Models Affected: RHFE-201FA, RHFE-263FA/FAII, RHFE-431FA/FAII/FAIII/WTA, RHFE-556FA/FAIII/FTRAIII/WTA

When accomplishing any maintenance or repair that involves removing the burner box fitting plate, it is recommended that the burner box plate, packings, screws, and electrode parts be replaced with the Burner Box Fitting Plate Kit, part number 204000018. Use of this kit will make the service procedure much simpler. Details of the kit and part locations are shown below.

Contents of 204000018

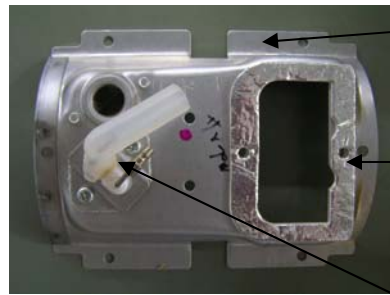
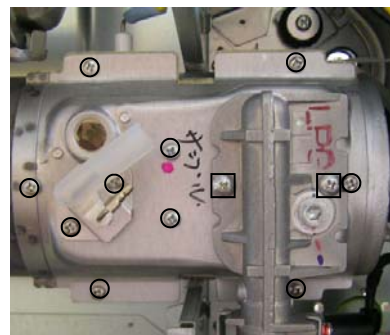
The old packing/gasket must not be re-used. It is necessary to replace this packing/gasket when accessing the burner area to guarantee a seal and prevent the appliance from operating in an unsafe condition. Damage to the appliance may also occur if the old packing/gasket is re-used.
